### **Council File Number 15-0317-- Case No. BF 140090 Appeal for 3923-3941 North Hopevale Drive**

Re: Council File No. 15-0317 - Case No. BF 140090  
3923 – 3941 Hopevale Drive – Haul Route Appeal

### **GRADING QUANTITY STUDY FOR 3923 HOPEVALE DRIVE CITY OF LOS ANGELES APRIL 10, 2015**

SECTION - G  
SCALE: HORIZ. 1"=20'  
VERT. 1"=20'

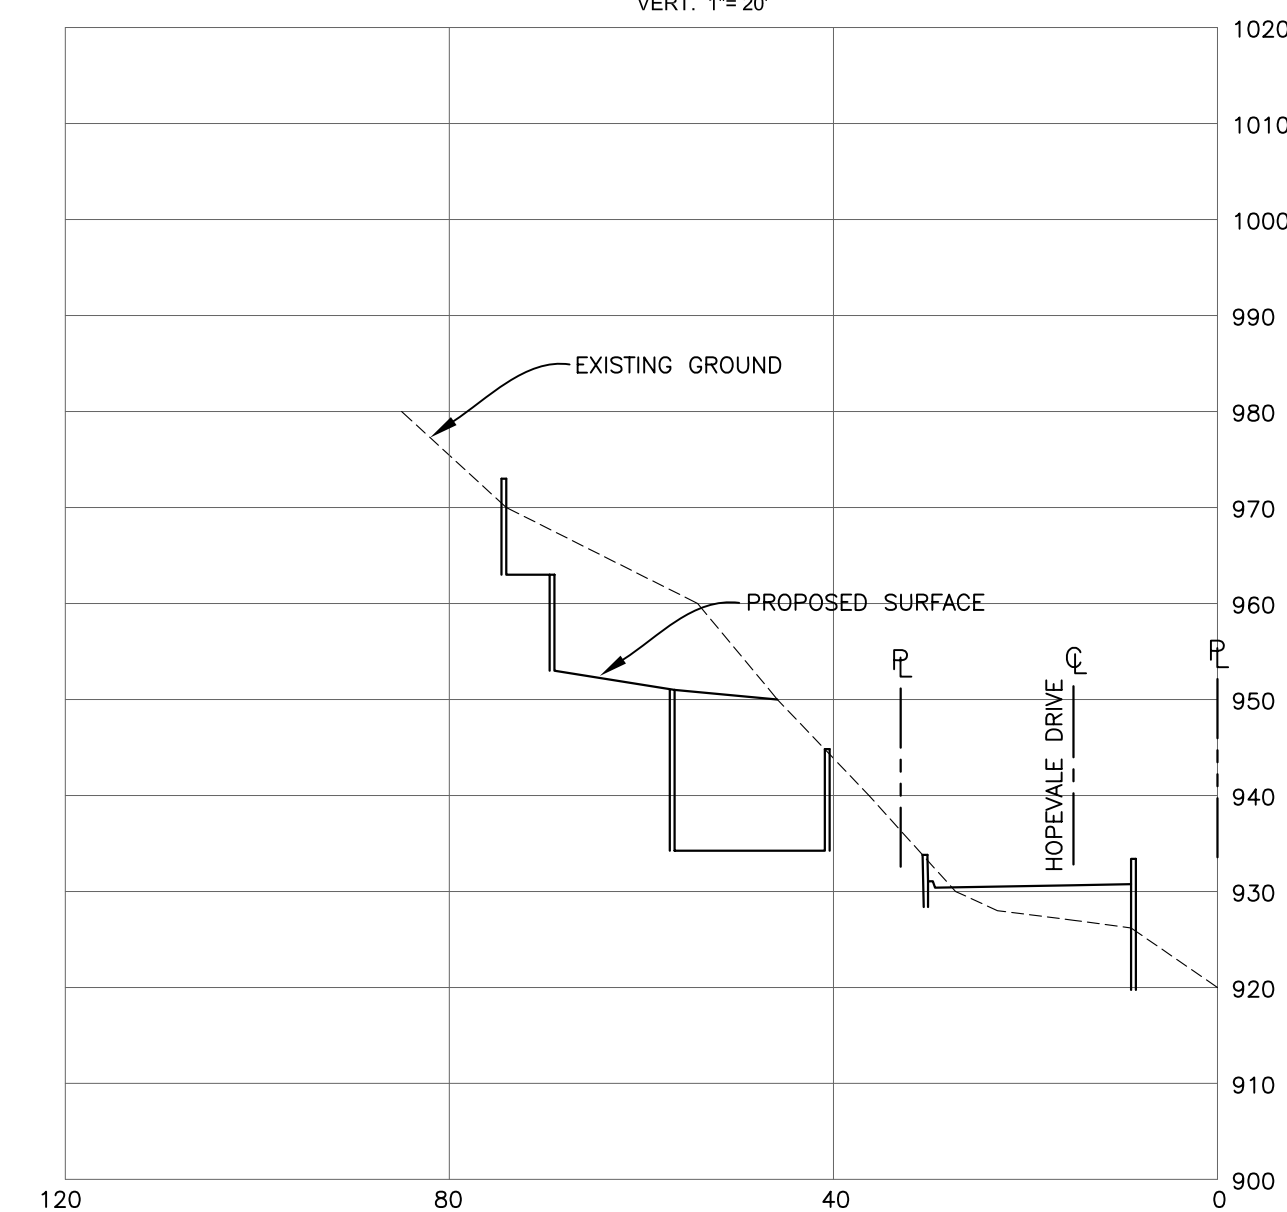
**NOTE**  
THE EXISTING GRADE SURFACES SHOWN HEREON FOR ELEVATIONS 928 AND BELOW (IN THE STREET AREA) WERE TAKEN FROM APPROVED STREET PLAN P-36633 AND DO NOT MATCH THOSE SHOWN ON THE PROPOSED GRADING PLAN. THE EXISTING GRADE SURFACES SHOWN HEREON FOR ELEVATIONS 930 AND ABOVE WERE TAKEN FROM THE PROPOSED GRADING PLAN.

SHEET TITLE:  
GRADING QUANTITY STUDY  
3923-3941 HOPEVALE DRIVE  
CROSS SECTIONS - WITH QUANTITIES

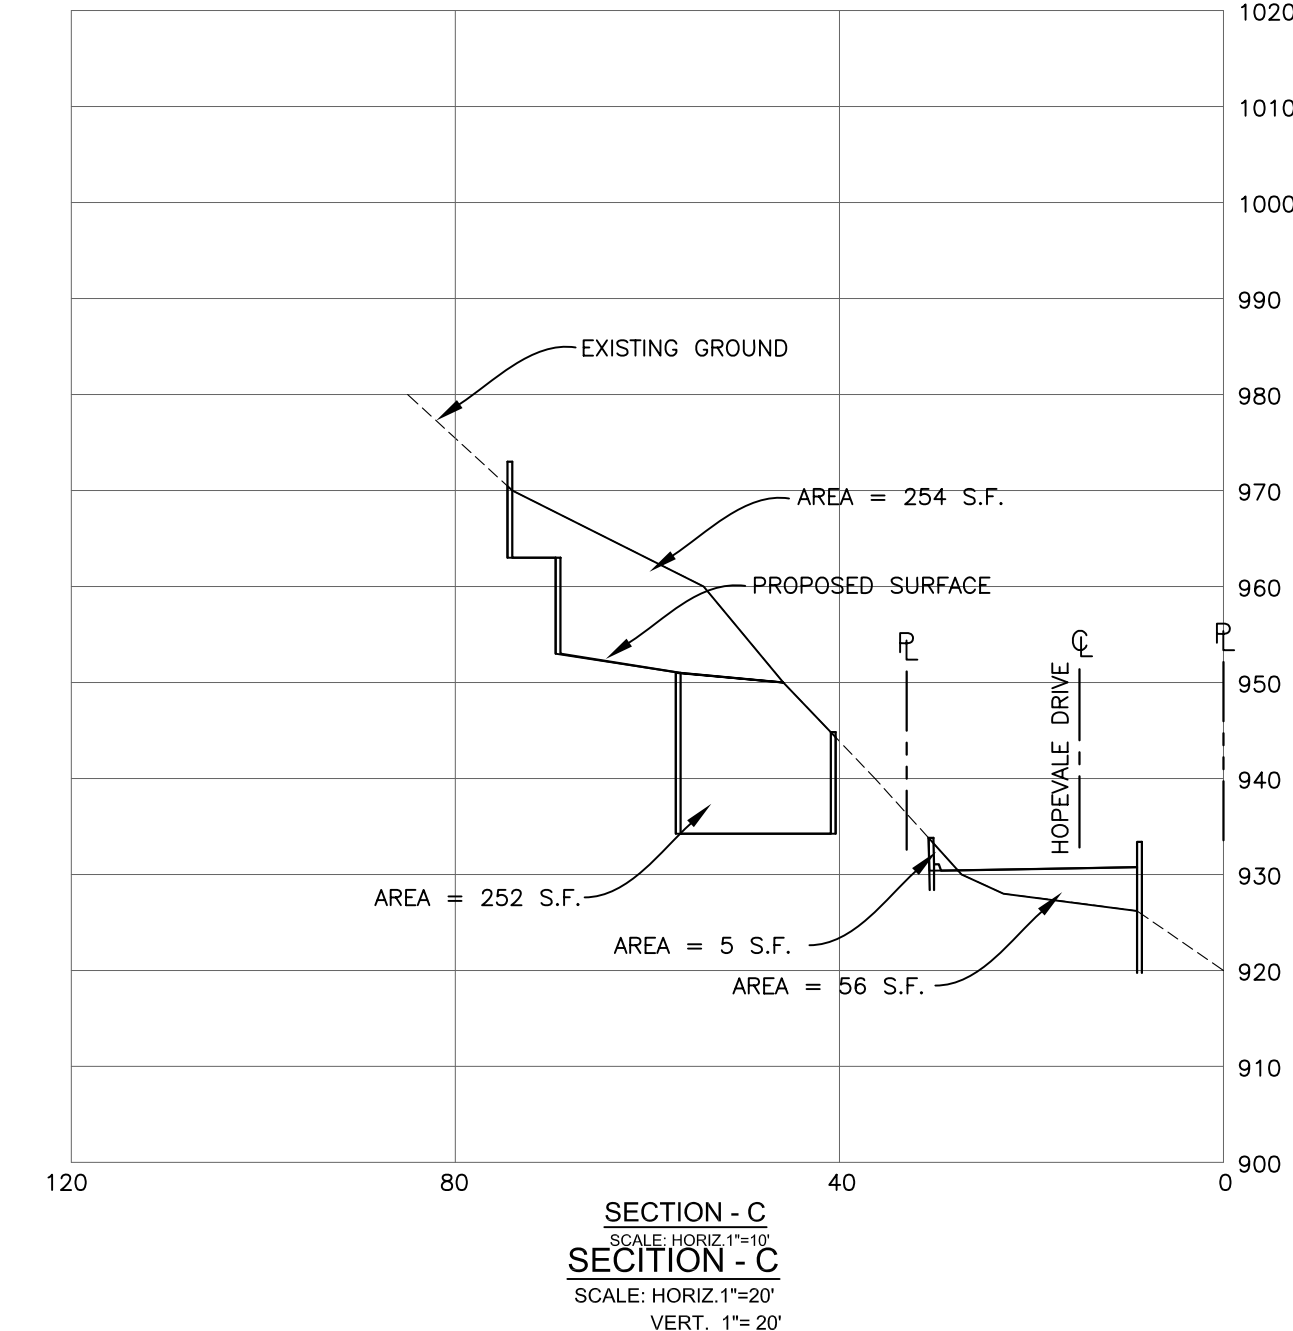
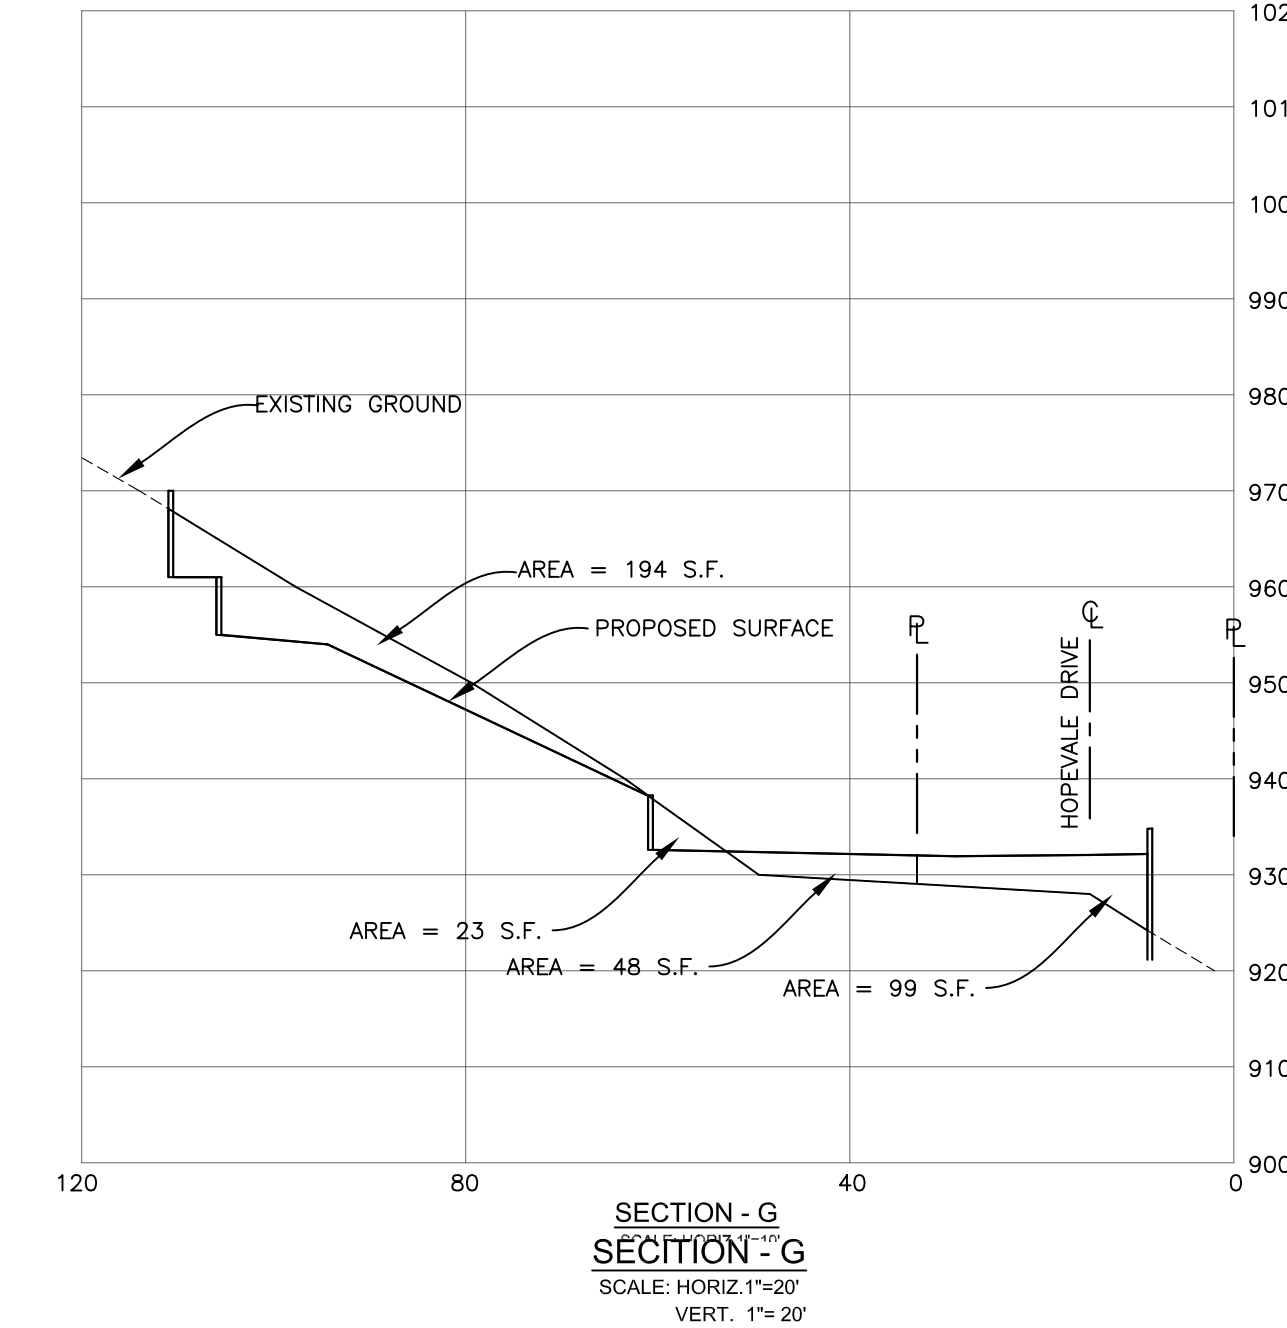
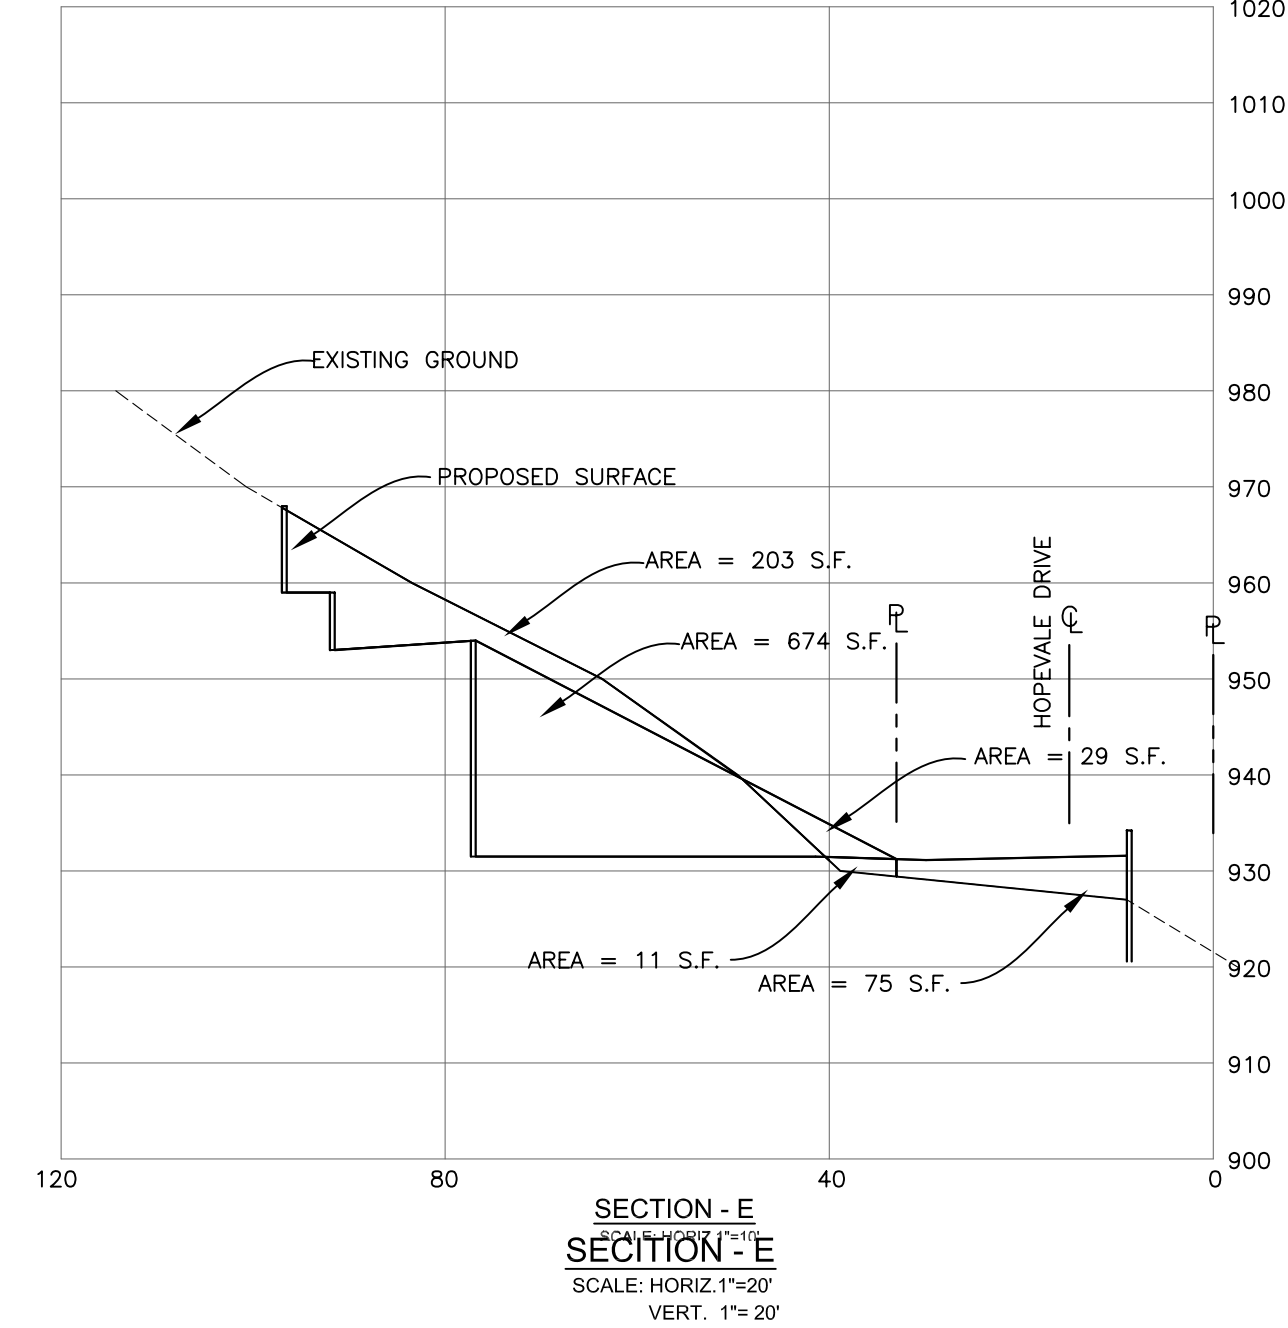
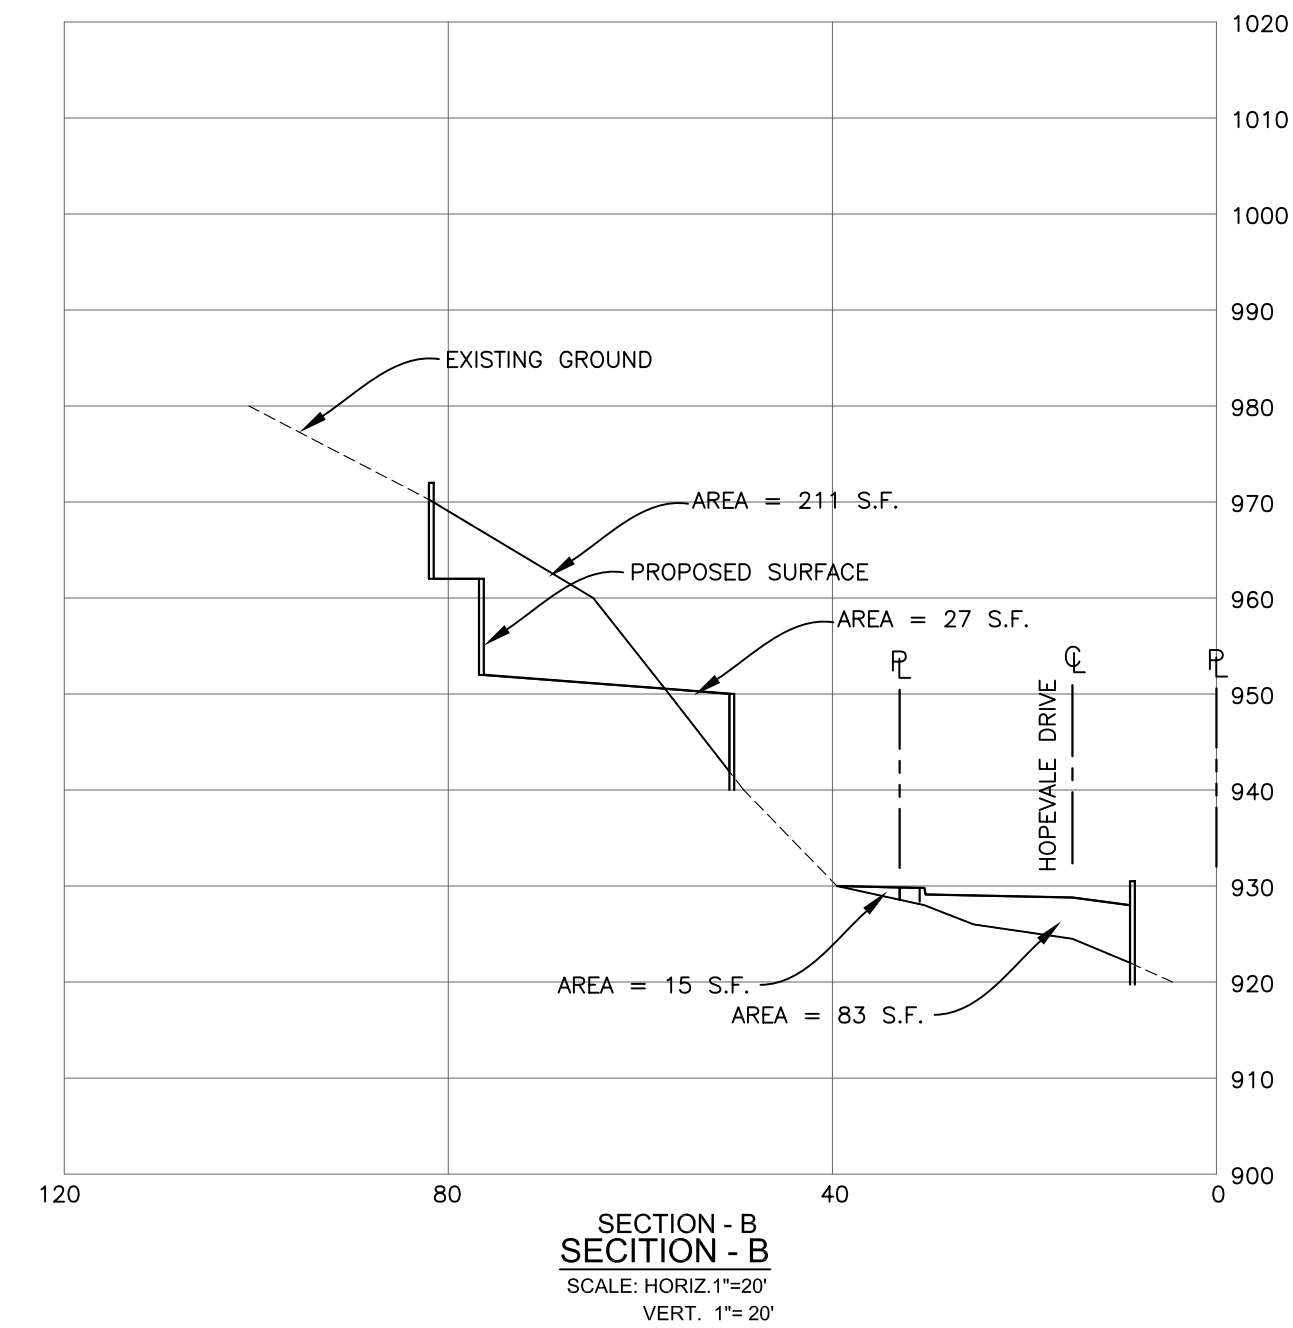
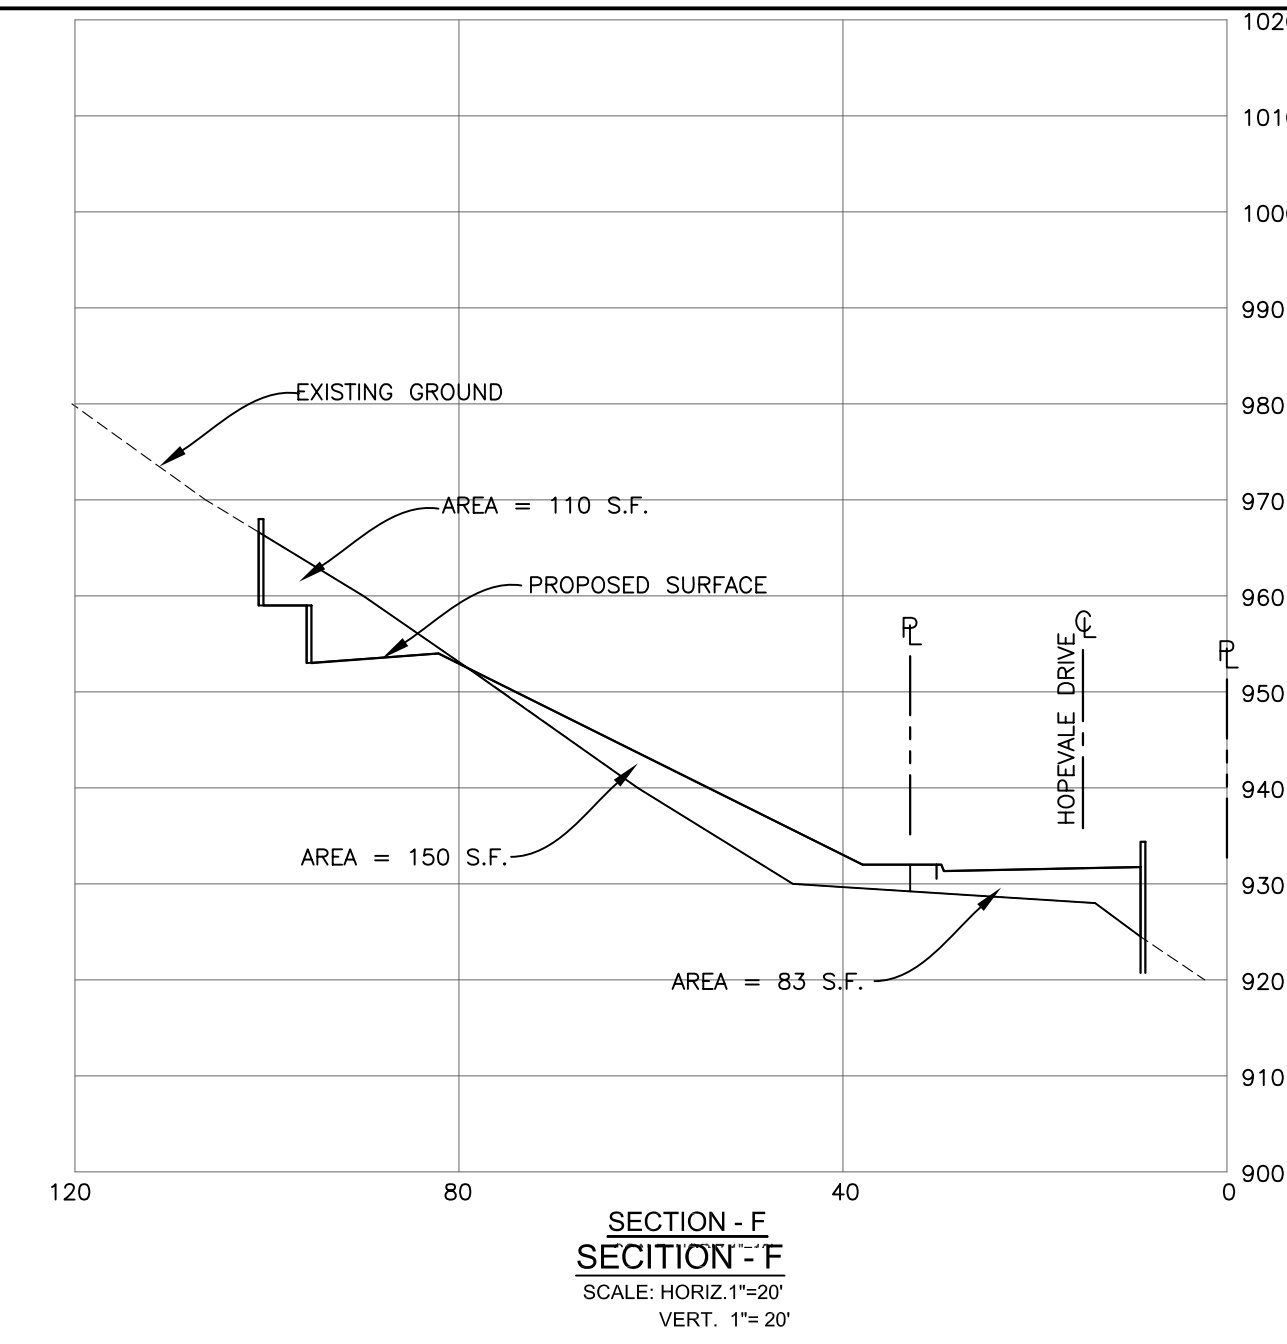
**NOTE**  
THE EXISTING GRADE SURFACES SHOWN HEREON FOR ELEVATIONS 928 AND BELOW (IN THE STREET AREA) WERE TAKEN FROM APPROVED STREET PLAN P-36633 AND DO NOT MATCH THOSE SHOWN ON THE PROPOSED GRADING PLAN. THE EXISTING GRADE SURFACES SHOWN HEREON FOR ELEVATIONS 930 AND ABOVE WERE TAKEN FROM THE PROPOSED GRADING PLAN.
